**STAFF REPORT**  
**COMMUNITY DEVELOPMENT DEPARTMENT**

HEARING DATE: 6/18/2020 9/17/2020  
 TO: Planning & Zoning Commission  
 FROM: Joe Dodson, Associate Planner  
 208-884-5533  
 SUBJECT: H-2020-0046  
 Gateway at Ten Mile

**I. PROJECT DESCRIPTION**

B. Bubble Plan (date: 6/8/2020) **(NOT APPROVED)**

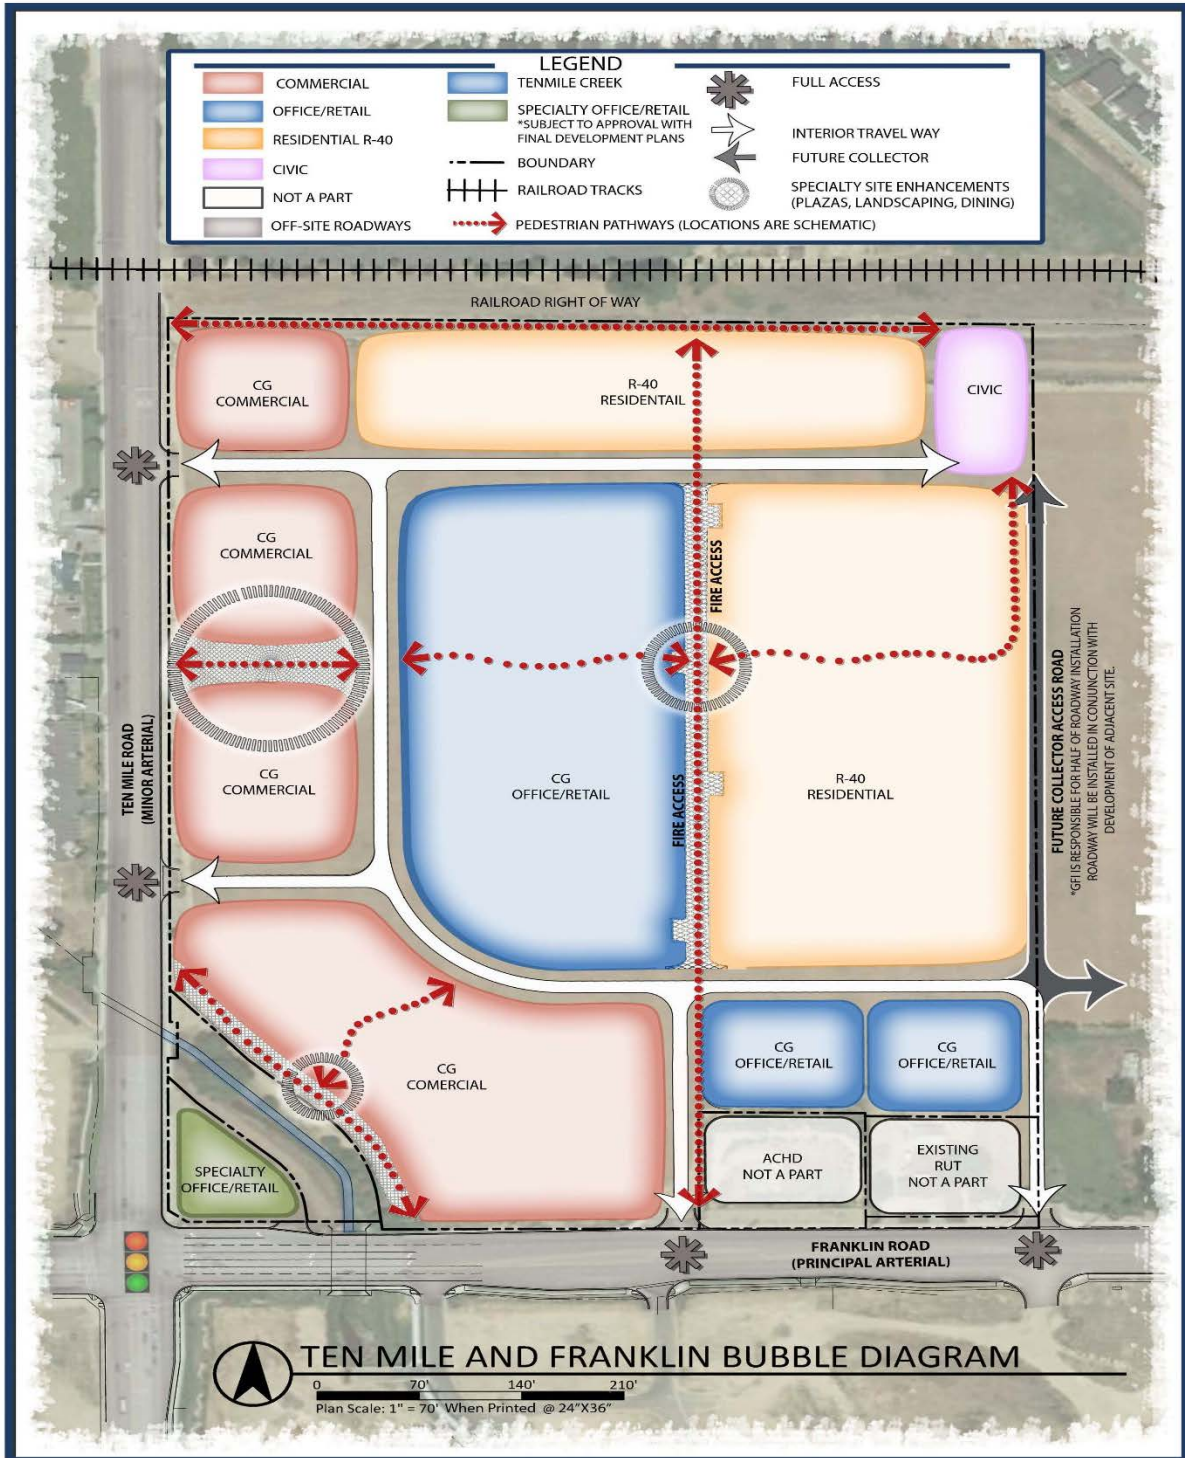
Because of these issues, Staff highly recommends that the bubble plan showing current areas labeled as office/retail and R-40 be revised to show a larger area of residential but with a combination of TN-R (Traditional Neighborhood Residential) and TN-C (Traditional Neighborhood Center District) zoning designations and provisions that at least 50% of the residential area be a combination of either Vertically Integrated structures or single family product types. This would provide a good deal of housing choice, opportunities to transition, and the necessary guidance to ensure transit oriented and traditional neighborhood design later, with only a bubble diagram. Vertically integrated and multi-family uses are principally permitted within the traditional neighborhood districts and much of the same commercial/retail/office uses are also principally permitted. Therefore, making these changes should prove less restrictive than the proposed R-40 zoning designation.

Even though the subject site is used for agricultural purposes and has historically been so, there are multiple curb cuts along W. Franklin Road and N. Ten Mile Road, arterial roadways. The submitted bubble plan shows the Applicant's desire to keep a majority of the existing curb cuts for future access.

- a. ~~The submitted bubble plan in Section VII.B is not approved as shown. At least ten (10) days prior to the City Council hearing, the Applicant shall submit a revised bubble plan reflecting Staff's recommended revisions herein.~~

- c. ~~The Applicant shall revise the bubble plan to show a larger residential area to include those areas shown as "office/retail" and annex into the City of Meridian with TN-C (Traditional Neighborhood Center District) and TN-R (Traditional Neighborhood Zoning District) zoning instead of the requested R-40 zoning designation. At least ten (10) days prior to the City Council hearing, the applicant shall provide revised legal descriptions and exhibit maps for the requested C-G and R-40 district and the recommended TN-C and TN-R zoning districts to reflect the revised concept plan as seen in Exhibit VII.C.~~

C. Revised Concept Plan (August 2020)

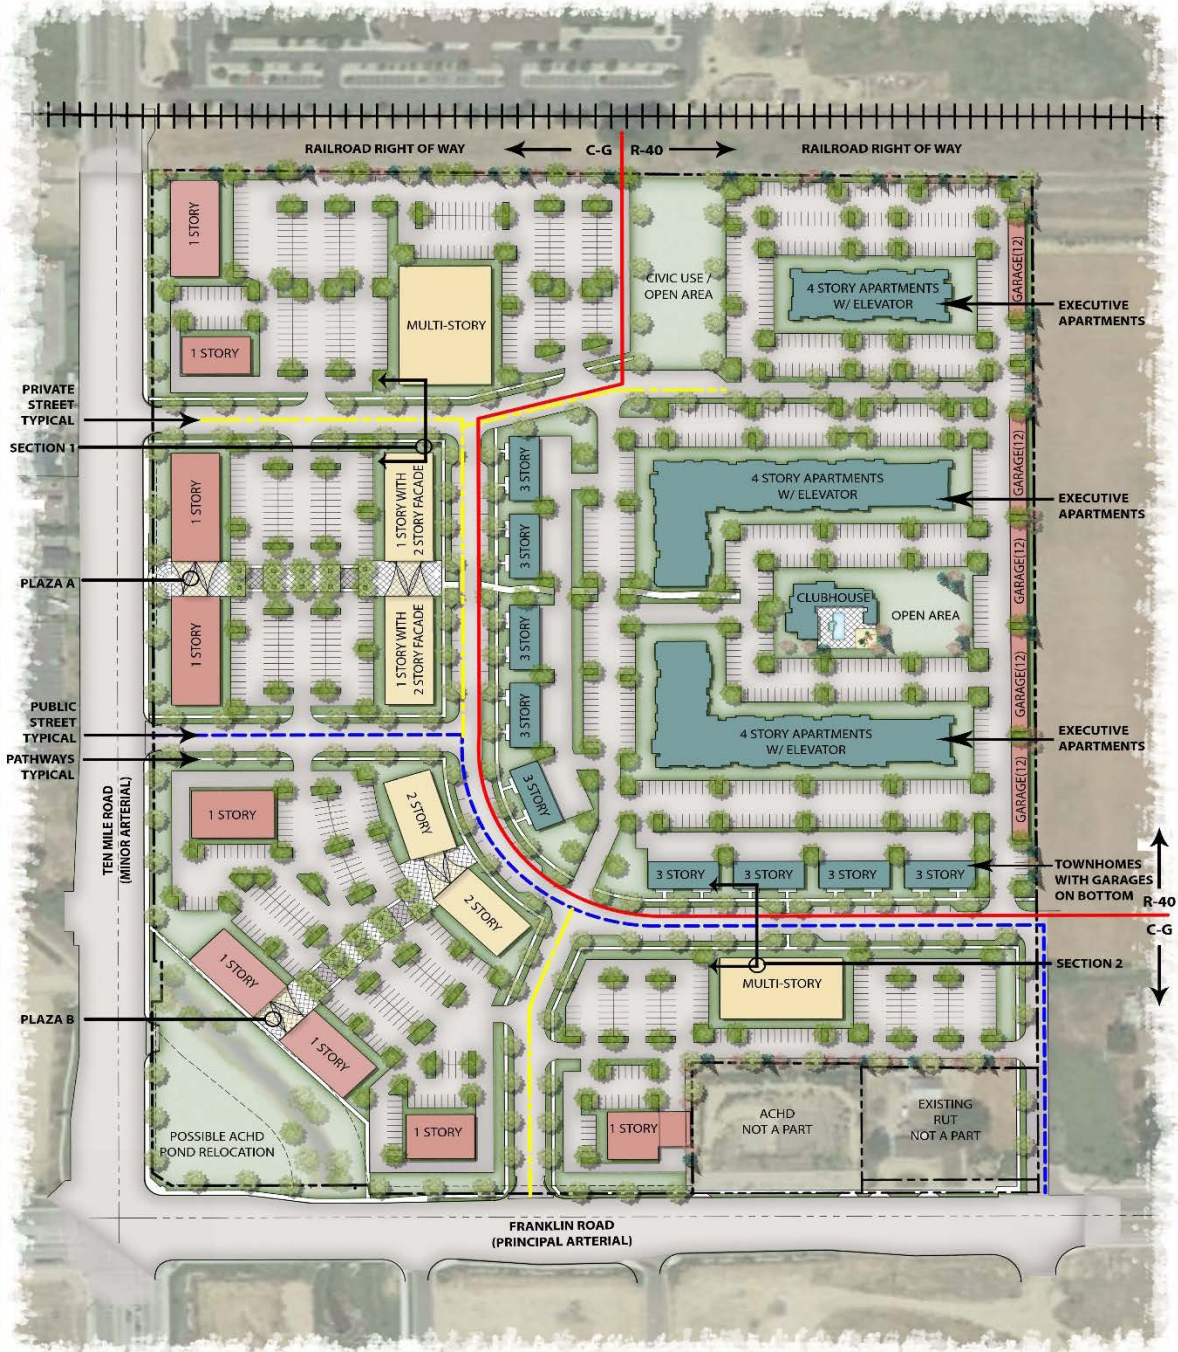
*In addition, the very southwest corner of the site is constrained by the Ten Mile Creek and will severely limit any use in this section of the site. ~~The bubble revised concept plan has a note stating “possible AHD pond relocation” in this area of the site. There is no guarantee that ACHD will agree to relocating their pond and the Applicant should be open to a number of possible options on this constrained piece of the property. shows a pedestrian connection to this area and no vehicular connection.~~ This corner of the property is approximately 1.5 acres (including the easement area) and is highly visible from public roadways. This area should be treated with great care and consideration of its intended use. ~~Staff can envision the pedestrian connection shown on the bubble plan leading to a nice integrated plaza for the commercial development on the east side of the Ten Mile Creek.~~ The Ten Mile Creek should be integrated with the future uses proposed in this area similar to the design concepts implemented with the approval of the TM Creek project to the south. Staff also recommends the Applicant work with the appropriate agencies and City departments to find the best use for this corner. There could be an opportunity to provide a public use on this side of the creek.*

- Incorporate plazas between compatible uses to provide shared outdoor seating and enhance pedestrian circulation between uses – *The revised ~~bubble~~ concept plan shows plazas between proposed commercial uses and a shared vista between the proposed office/retail area and the high-density residential. This revised layout shows better pedestrian connection between uses and should greatly help activate the commercial uses. Again, ~~annexing in this property with the traditional neighborhood zoning designations instead of R-40 would greatly help in achieving this goal because of its pedestrian-oriented design requirements in the Plan and the UDC.~~ Some flexibility in the location of these should be assumed in the future, to ensure maximum benefit from a variety and mix of uses and various intensities and scale.*

Directly to the east of this site is I-L zoning and a new Fed-Ex distribution center is nearing construction. Even though the MSM and TMISAP show the future collector roadway going further north along the shared property boundary and then heading east, Fed-Ex was not required to build a portion of the collector roadway going north-south on this shared property line. Instead, they were approved with an east-west collector road further south within their property that aligns with the proposed east-west roadway in the southern area shown in this application. This location of the collector roadway is clearly different than that shown within the TMISAP. This new location should still offer adequate cross access between parcels once fully developed but has also changed the type of future access to the Civic use in the northeast corner of this site where the collector roadway would connect to. Since the Fed-Ex distribution center was approved without constructing the north-south collector, ~~Staff does not have authority to require them to do so until that site redevelops. Therefore, the future north-south collector roadway shown on the MSM, it is not a feasible option to require this Applicant construct their portion at this time. submitted bubble plan in this application would need to be wholly constructed on this property and by this Applicant if it were to develop as shown. Staff is concerned that this is unlikely due to the circumstances outlined. Instead, Staff believes at least a public local street should be built along the eastern boundary of this site for future connectivity to the collector roadway in the southeast corner of this site that will connect to Franklin Road and for~~ Instead, Staff believes adequate access to any future transportation use ~~is~~ along the north boundary northeast corner of the site, shown as the Civic land use on the concept plan, can be obtained via an east-west public street connection to Ten Mile Road as depicted on the concept plan. A potential alternative to this would be to move the Civic use further west, still along the northern boundary but behind the commercial fronting Ten Mile, and ensure Staff believes the travel way shown in the north of the site ~~is~~ should be built as a full public access (at least a local street) to handle future traffic to and from a transportation hub instead of the private street shown on the concept plan.

In addition to the access points to Ten Mile and Franklin Road, there will be travel ways within the development. These areas appear to be shown on the ~~submitted bubble~~ revised concept plan as a combination of public streets, private streets, and drive aisles, and not full public streets and their locations may change in the future as more specific development is proposed. The road network will be the backbone of the connectivity for this development and is therefore incredibly important to the future development of this site. Staff would prefer the main travel way shown that starts in the southeast corner and curves up towards the northwest corner of the property be a public local street. ~~This is currently not a requirement due to no TIS being required at this time but~~ Staff believes creating a genuine public thoroughfare would help traffic flow and create a grand drive through the development lined with street trees and pedestrian walkways.

- l. The Applicant shall construct the east-west street in the northern portion of the site as a full public street along the eastern property boundary and wholly on this property starting at the collector roadway in the southeast corner of the property and ending in the northeast corner of the site where the Civic future land use is shown on the bubble revised concept plan in Exhibit VII.C.

- s. If an agreement with ACHD to relocate their pond to the constrained piece in the southwest corner of the site is not accomplished, The Applicant shall coordinate with the Parks Department to include a public amenity (trail hub lot) in the southwest corner of the site, labeled as specialty retail possible ACHD pond relocation on the bubble concept plan. If an neither agreement with the Parks Department cannot be made, the Applicant may construct this area with a specialty use that allows for an activity node for the development. Future development plans shall show this area of the bubble concept plan with greater detail following these discussions.

## D. Applicant's Proposed Development Agreement Provisions

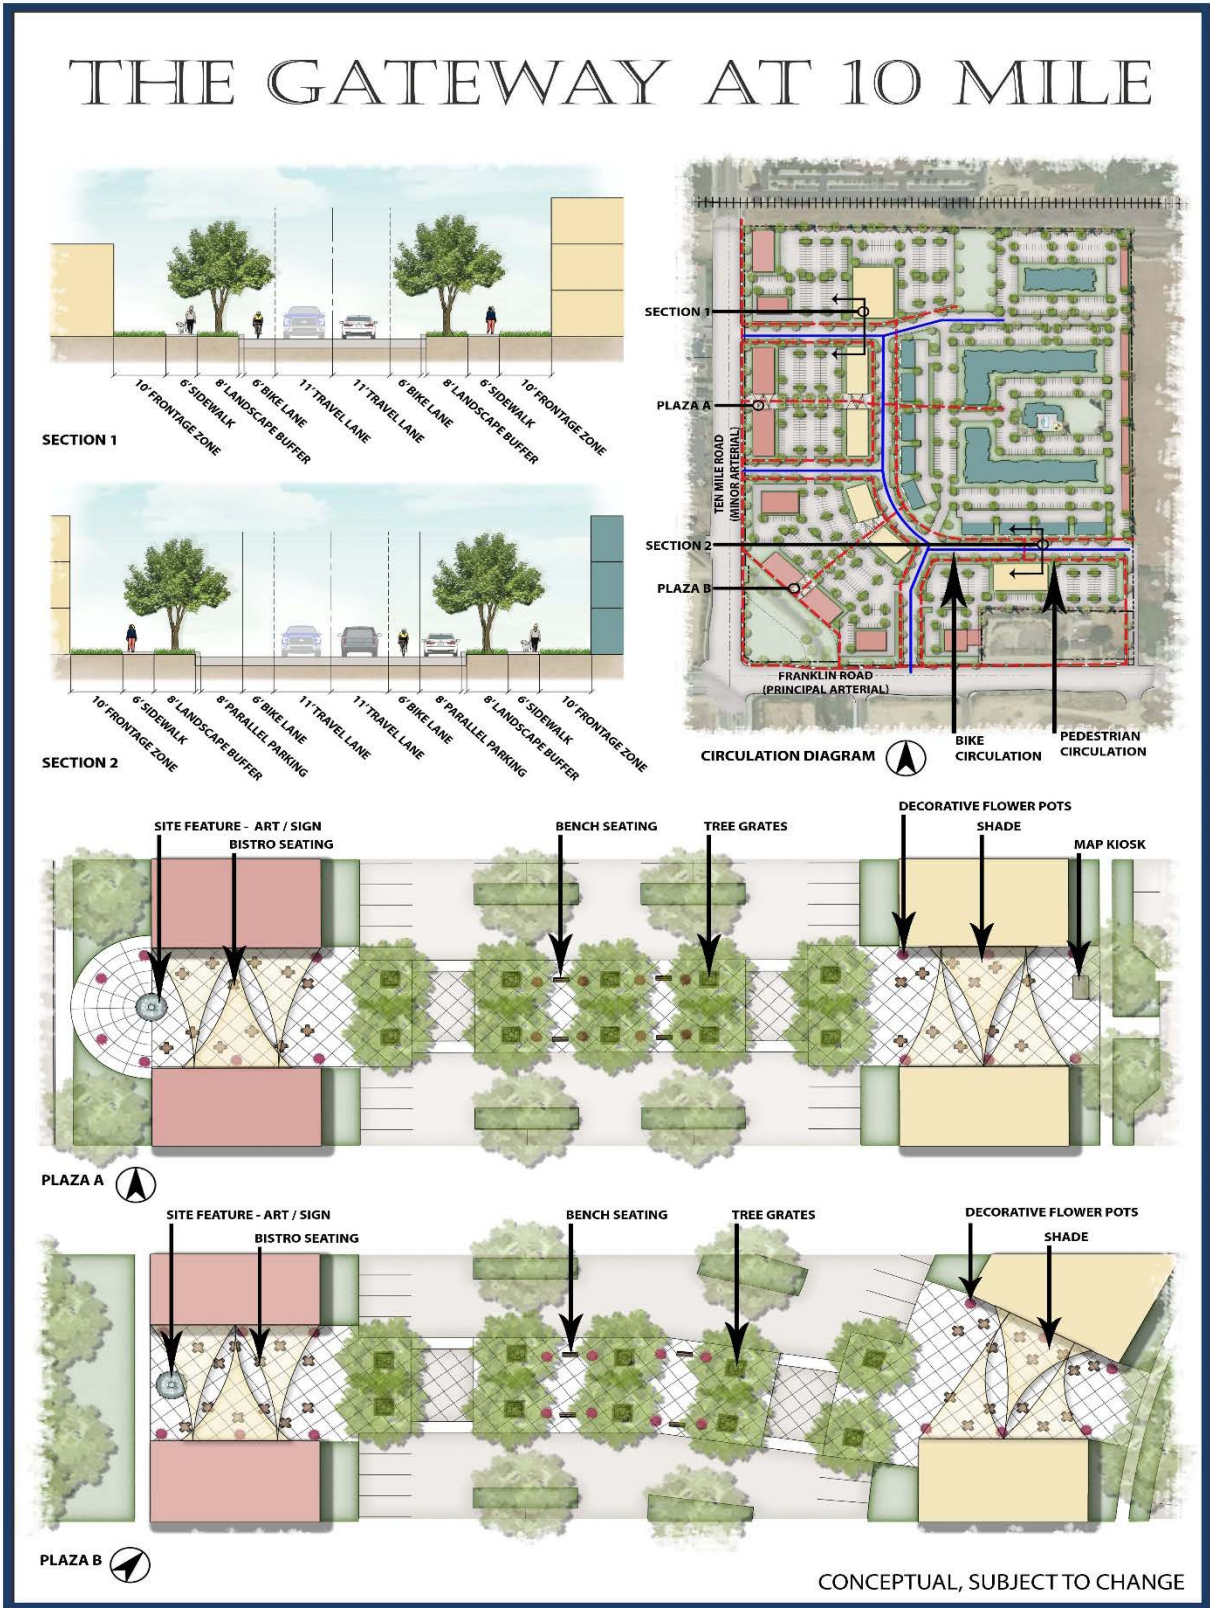
*and the TMISAP goal of two-story or more structures. In response, the Applicant has included a proposed DA provision that would require ~~at least one multi-story structure along each arterial roadway. The condition also notes that other some of those structures along the main interior road that may be single-story would be designed in such a way that their building facades appear to be a two-story structure. Staff is supportive of this provision so long as it does not include more than the two buildings shown to be affected by this requirement as depicted on the submitted concept plan. Staff is supportive of this but in reality this provision helps add a look and feel to the scale of architecture instead of aiding in adding density so Staff is not overly concerned with this. Instead, Staff is recommending a provision that all commercial structures along the main thoroughfare (the only road shown with on-street parking) have a ceiling height of at least 15-feet for the ground level commercial—this includes those buildings shown as single-story with two-story facades. This provision is consistent with language within the TMISAP (see page 3-38 within the plan). Instead of trying to create the look of two story structures on single story buildings, Staff is recommending a DA provision that allows no more than two (2) future commercial buildings along each arterial (Ten Mile and Franklin) within the C-G zoning district to be single story. Three and four story non-residential or integrated mixed use buildings could be used to request additional 1:1 allowance for more single story structures later, assuming continued integration of mixed use commercial site design principles. Staff will review each building site as future land use applications are submitted for compliance with ~~this goal~~ the proposed provisions but is not inclined to hold the Applicant to specific FAR requirements.~~*

5. In place of the fourth bullet point shown in Exhibit VII.D, the following provision shall apply: Minimize single-story structures; on single-story structures, use architectural facades to add height wherever possible and visually effective.
